**STATE OF CALIFORNIA
ENERGY RESOURCES CONSERVATION
AND DEVELOPMENT COMMISSION**

Docket No.
09-Renew EO-01

**COMMENTS OF THE
CALIFORNIA WIND ENERGY ASSOCIATION
ON THE DRAFT INTERIM MITIGATION STRATEGY**

DRECP Proposed Mitigation Areas in Relation to 80-meter Wind Resource

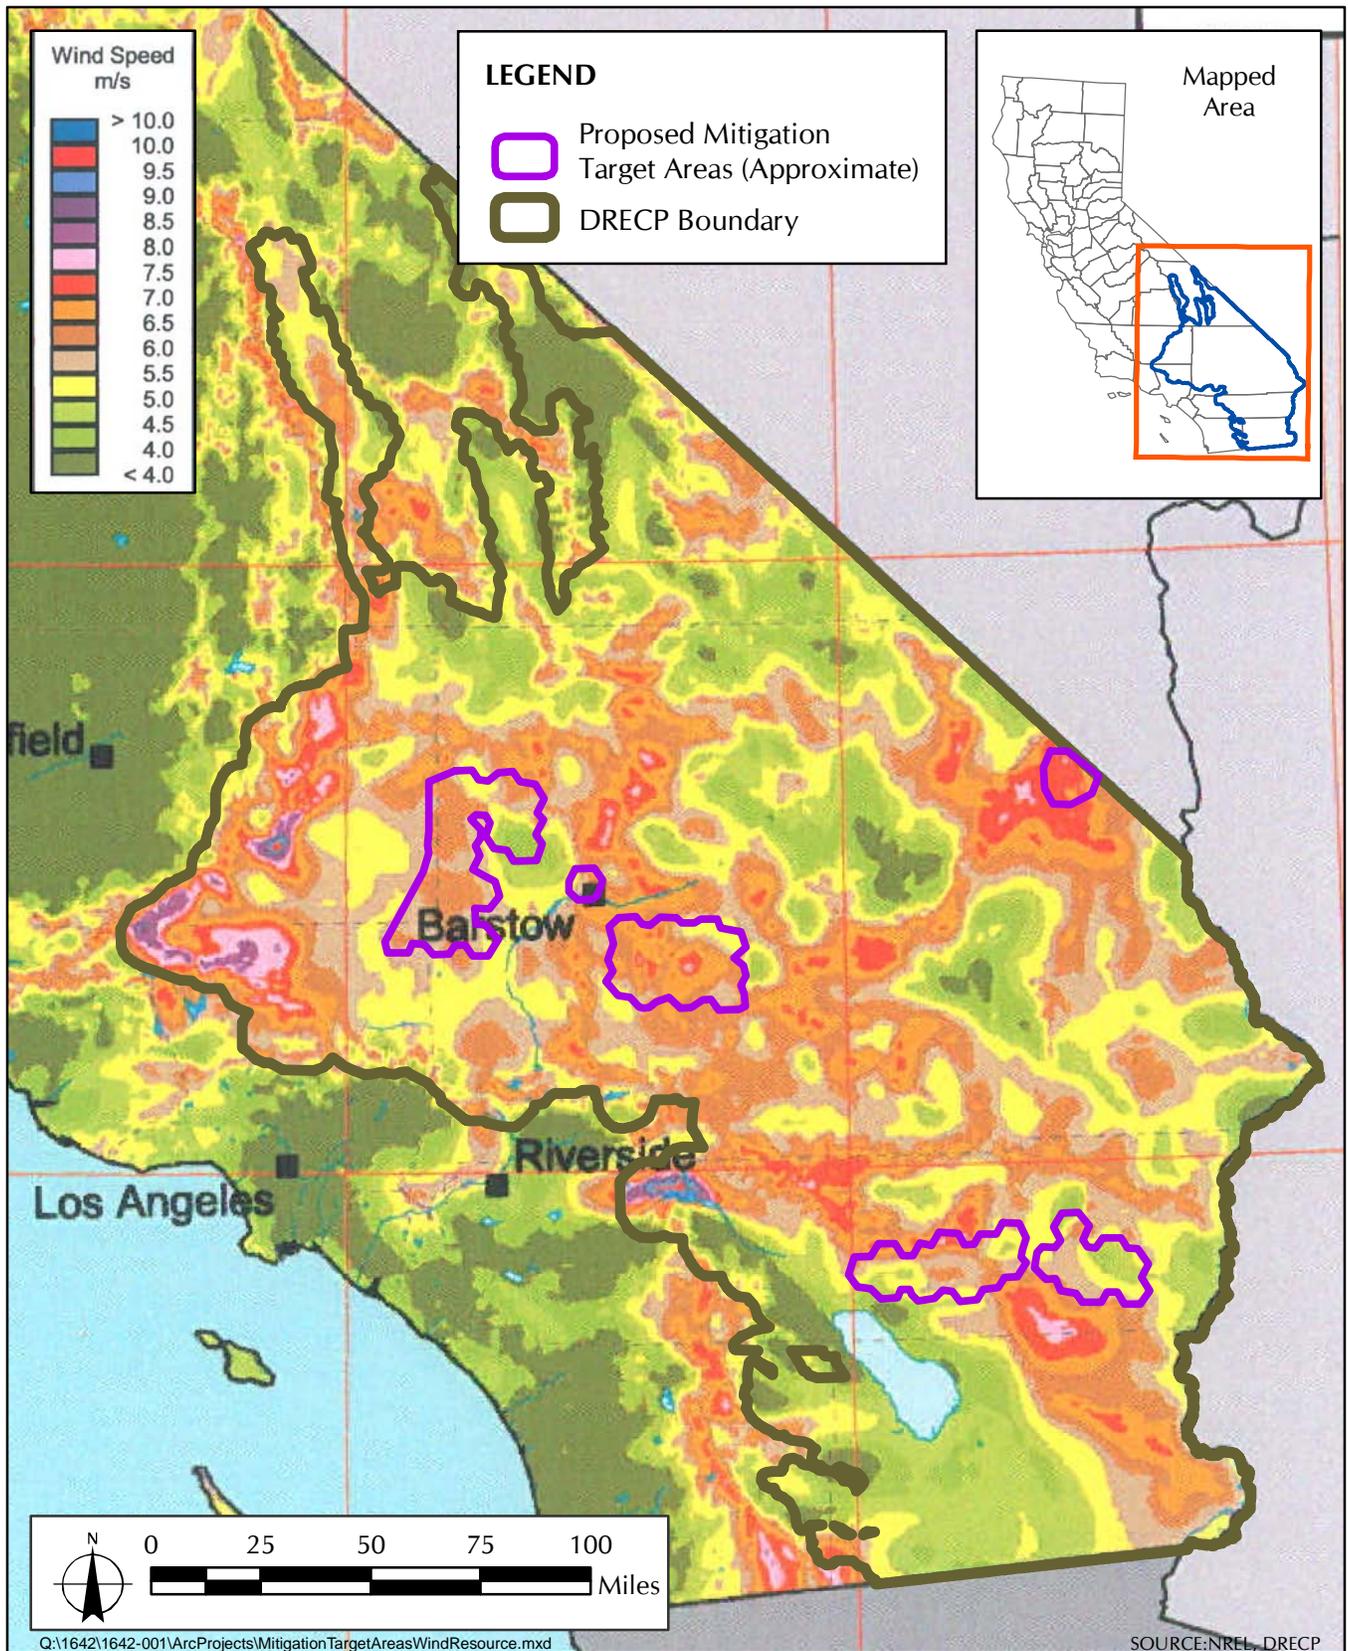
First and foremost, in identifying the proposed Mitigation Target Areas (MTAs), it appears that no effort was taken to avoid lands containing high wind resource potential. Indeed, the majority of the land area within the six proposed MTAs contains wind resources of Class 6 or higher (see attachment below). CalWEA considers Class 5 winds and above to be worthy of preserving for development under the DRECP, given the technology advancement that is likely to occur over the next decade and certainly by 2050 -- the timeframe for meeting California’s long-term greenhouse gas reduction goal. The MTAs would also significantly impact or completely eliminate four active wind project development areas. This includes one late-stage project on Governor Schwarzenegger’s “fast track” list that is seeking to qualify for federal tax credits under the American Recovery and Reinvestment Act, which has in place an executed power purchase agreement, an interconnection agreement, and a turbine supply agreement.

Illustrating both of these points is an area of active wind project development included in one of the MTAs -- the Castle Mountains area marked by three hexagons in eastern San Bernardino County adjacent to the California/Nevada state line, comprised mostly of either BLM or private lands. This designation was not discussed in advance with DRECP stakeholders, including CalWEA and its member company that has invested significant resources in evaluation and environmental review of that site. Had it been, we would have pointed out the following reasons why the Castle Mountains area is inappropriate for inclusion in an MTA, as further described in the July 23, 2010, comments of Oak Creek Energy Systems:

- The area contains very high wind resource potential (i.e., Class 7 resources at the hub height of current technology – some of the best remaining wind resource potential available in the state) and is proximate to transmission.

It is essential that, as the state seeks to expedite the development of one renewable resource, we do not thwart the development of another (particularly a very competitive resource that imposes relatively little ground disturbance). The Draft IMS must therefore be reconsidered carefully to determine whether the IMS’s goals can be achieved without in the process eliminating the development potential of high quality wind resource areas. If the proposed MTAs remain intact in the final IMS, and the IMS is claimed to be consistent with the emerging DRECP, as is required, then the DRECP can only be seen as a threat to achievement of one of its central purposes: to promote renewable energy development enabling achievement of the state’s renewable energy and greenhouse gas reduction goals.
